# SERVICE INFORMATION LETTER

SERVICE INFORMATION LETTER NO. T-013

1. SUBJECT: Serialization of Vibration Absorber Beams
2. MODEL: TH-28 and 480
3. EFFECTIVITY: TH-28: Serial Numbers 3004 and 3006  
480: Serial Numbers 5001 through 5037
4. BACKGROUND:

**FIGURE 1. DATA TAG LOCATION**

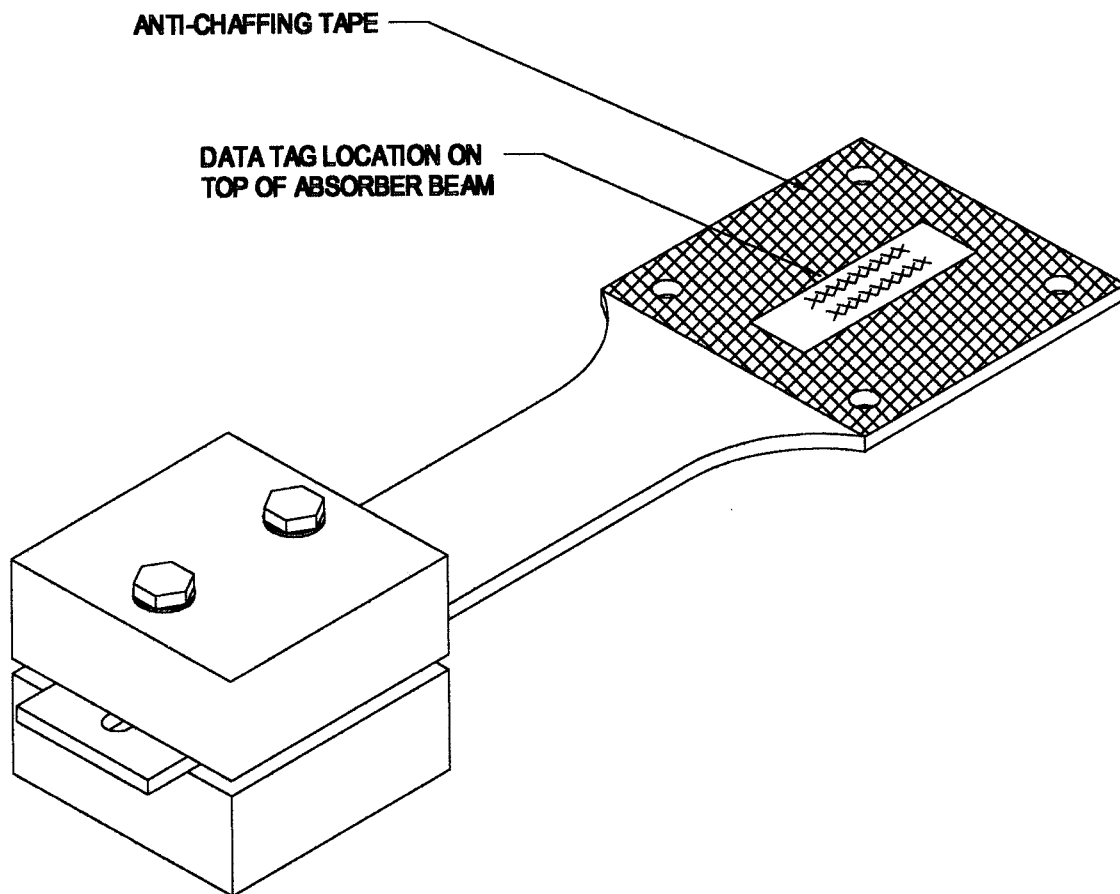
- 5.1.3. Clean the area for the data tag on the beam with isopropyl alcohol and install the data tag (See Figure 1).
- 5.1.4. Reinstall the absorber beam assembly and torque the bolt assemblies to 75 in-lbs (8.5 Nm).
- 5.1.5. Complete the required information on the component record card and insert into the airframe logbook. The component record card must show the time when the vibration absorber beam was actually installed on the aircraft, not the time when this Service Information Letter was complied with.
6. SPECIAL TOOLS: None
7. MAN-HOURS: .5 Manhours
8. WARRANTY: Per Enstrom Warranty Policy
9. WEIGHT CHANGE: None
10. LOG BOOK ENTRY: Enter compliance with this Service Information Letter
11. REPETITIVE INSPECTION: None
